SUBJECT: Final Remedial Design Work Plan for the Ash Landfill Operable Unit and Draft Final Construction Completion Report for SEAD-25 and SEAD-26 at Seneca Army Depot Activity; Contract FA8903-04-D-8675, Delivery Order 0012, CDRL A001B, A001C, and A004

**FINAL
REMEDIAL DESIGN WORK PLAN
FOR THE ASH LANDFILL OPERABLE UNIT
SENECA ARMY DEPOT ACTIVITY**

Appendix B
Response to Comments

**FIGURE 2-2
 ASH LANDFILL
 SITE MAP**

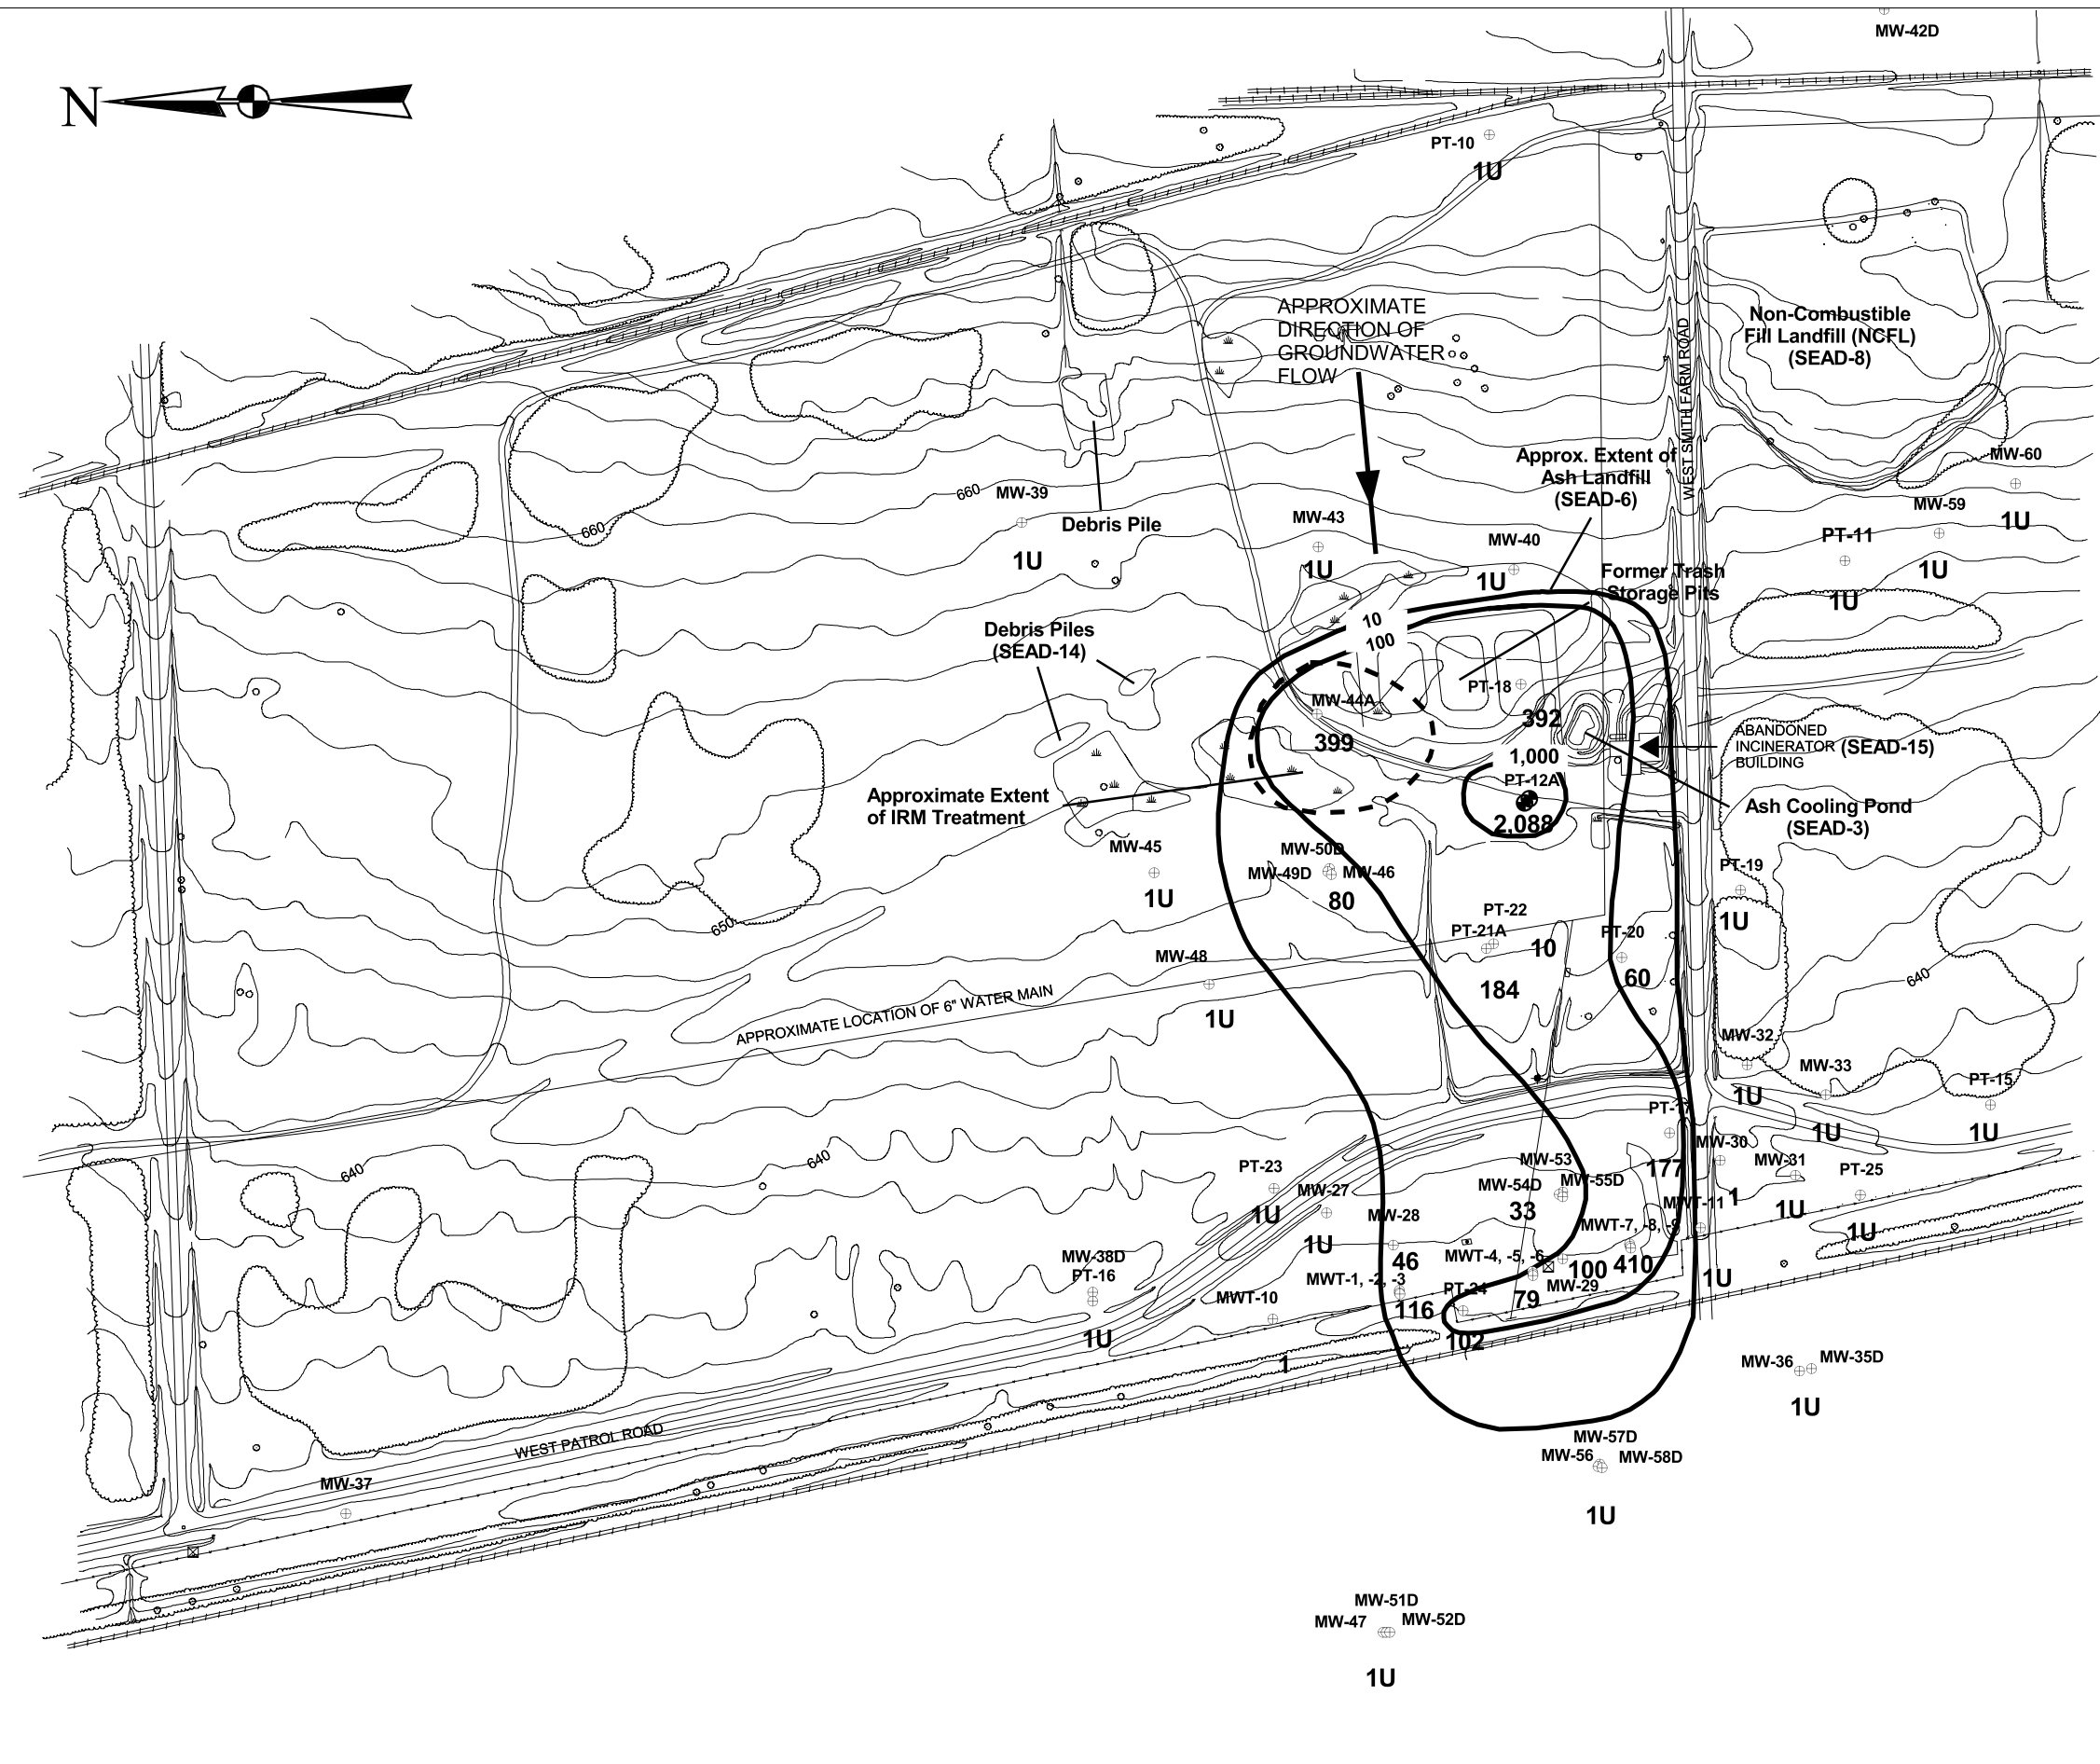
Comment 4: Figure 2-2, "Ash Landfill Site Map". The "Approximate Extent of IRM Treatment Area" is noted, but not delineated on the figure. Figure 2-2 should be revised to show this area.

21, along the south biowall transect are not depicted between PT-12A and MW-22. Figure 2-2 should be revised to include all monitoring wells incorporated in the biowall monitoring network.

Figure 3-2
Fraction of Total Ethenes Along the North Transect - Round 2

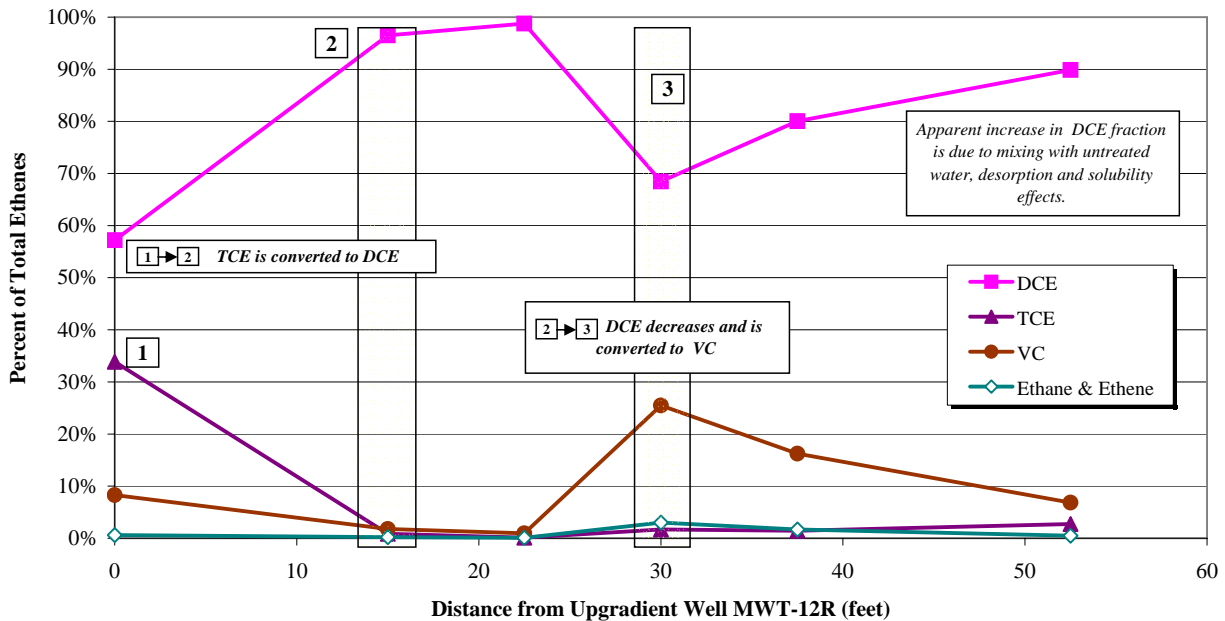
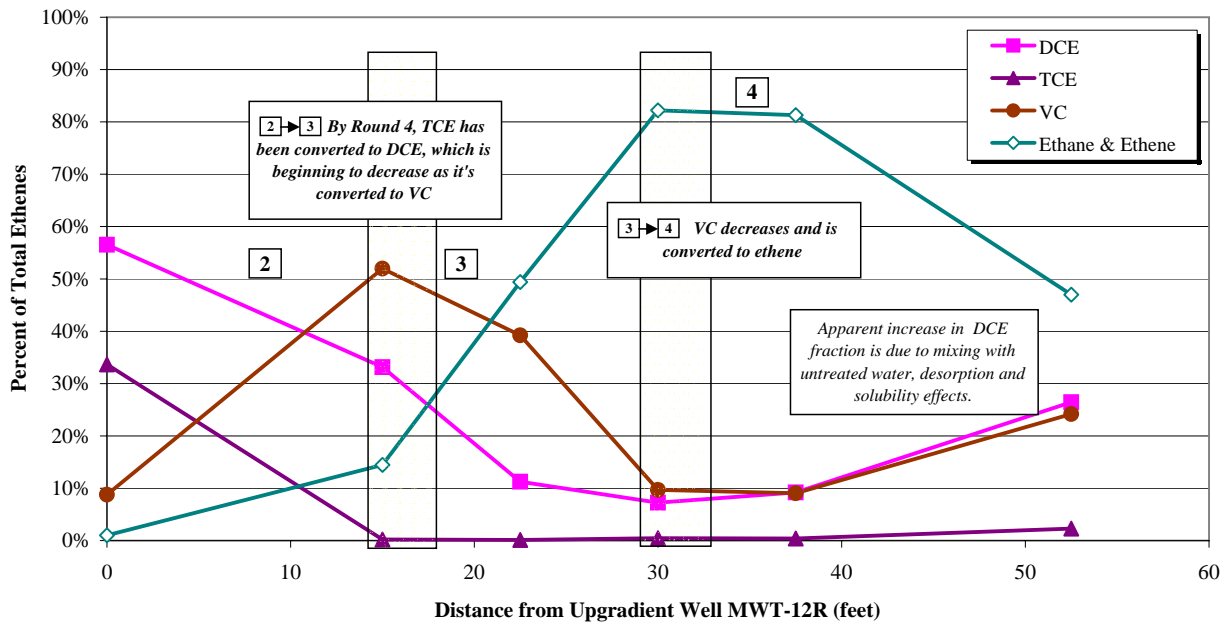
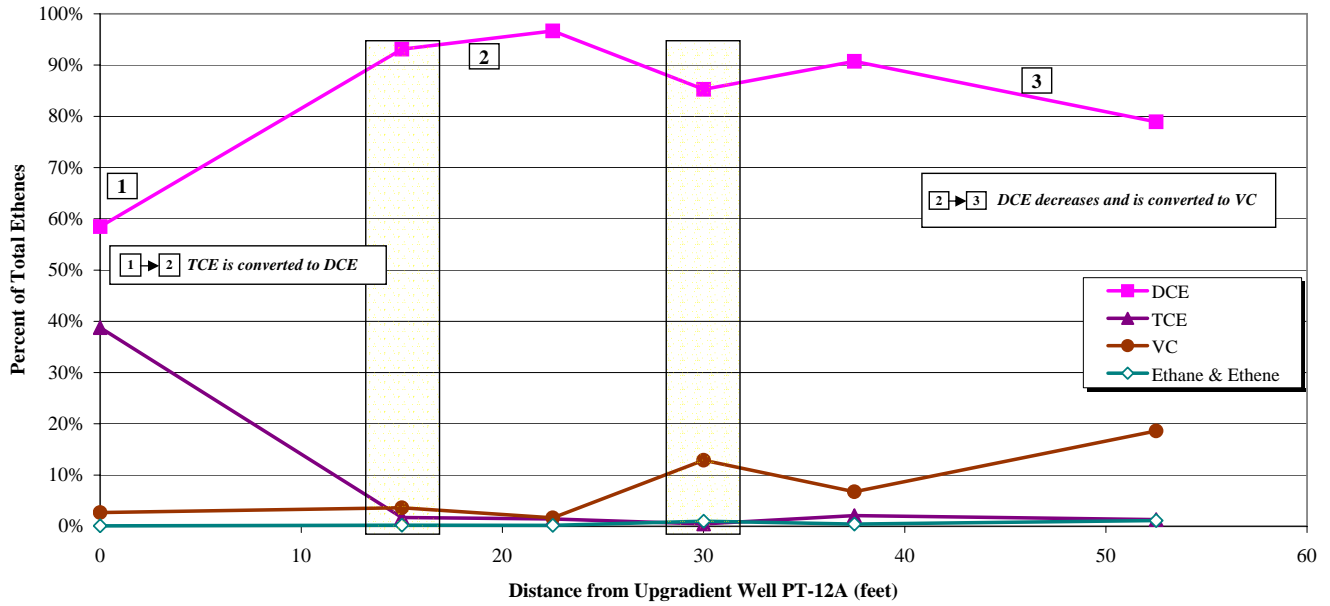
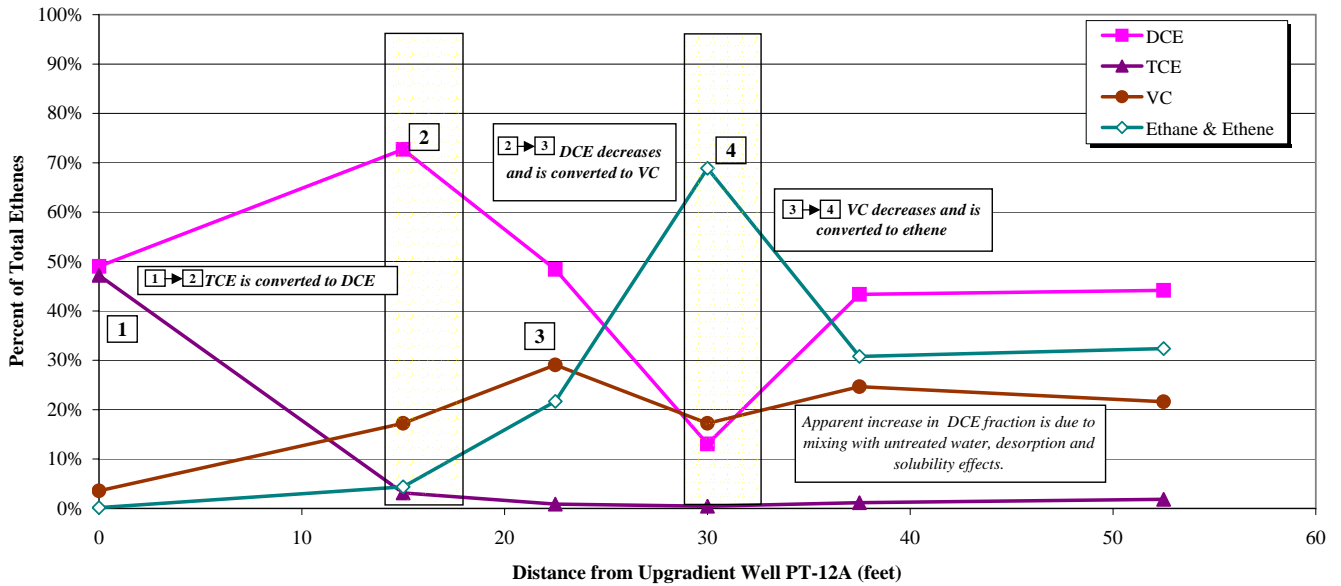
Comment 6: Figures 3-2 through 3-5. A note should be added to clarify that the rectangular objects on the graph located at approximately 15 feet and 30 feet along the x-axis (downgradient of the well MWT-12R) represent the eastern PRB and western PRB, respectively.
